**SERVICE BULLETIN**

80

INSPECTION OF TRIM CABLE PROTECTIVE SLEEVES

T67B, T67C Series, T67M, T67M-MkII, T67M200, T67M260 and T67M260-T3A.

FIG 1
TRIM CABLE

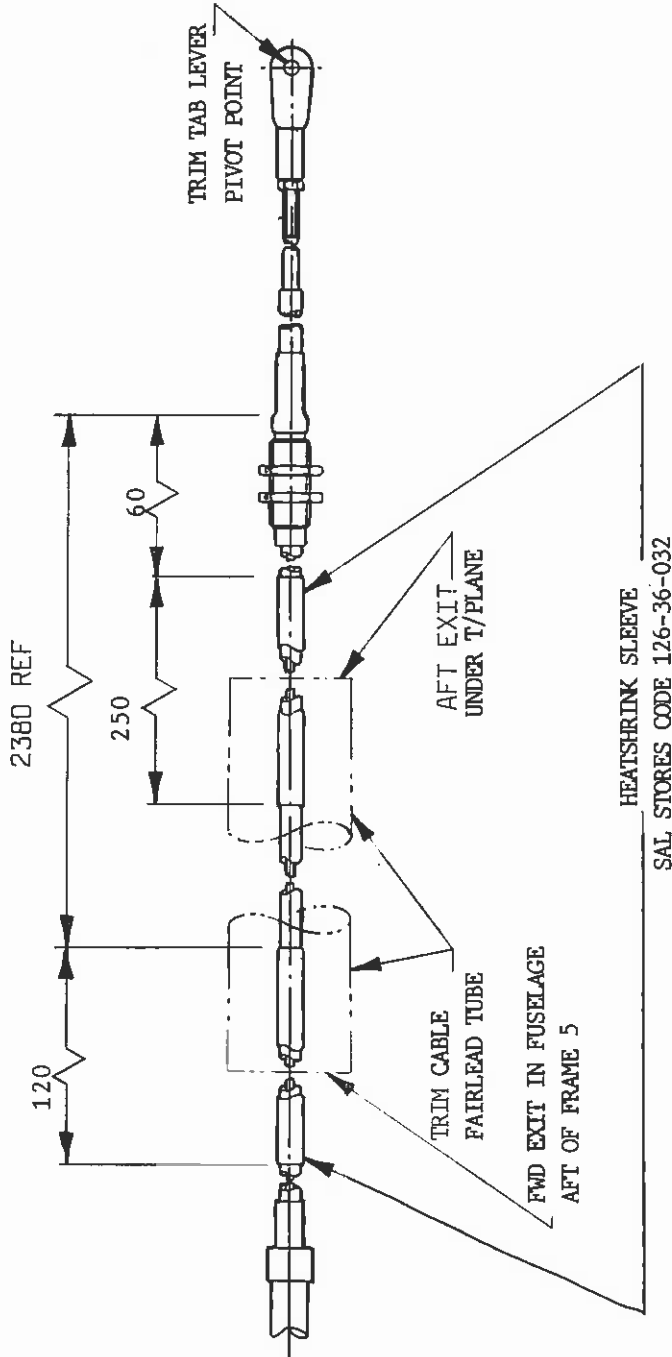
On further investigation it was found that the trim cable protective outer sleeving (heatshrink) had worn through to the metal casing at the trim cables exit aft point, which is located under the port tailplane. When compared to the other aircraft in the fleet, the extra sleeving over this area was seen to be missing.

1. Inspect trim cable at its aft exit, under tailplane, and at its forward exit, located in the fuselage behind Frame 5.
2. Inspect for existence of protective sleeve, refer Fig. 1 for positions.
 - i) If protective sleeve is fitted, check condition, replace as necessary.
 - ii) If protective sleeve is missing at either end, fit heatshrink in positions indicated. Ref. Fig. 1.
 - iii) If protective sleeve is positioned away from trim cables fairlead forward exit, then fit new sleeve at Dim 2380, Ref Fig. 1.

Note: Ideally the sleeves should be centrally mounted about exit points when the elevator is neutral.
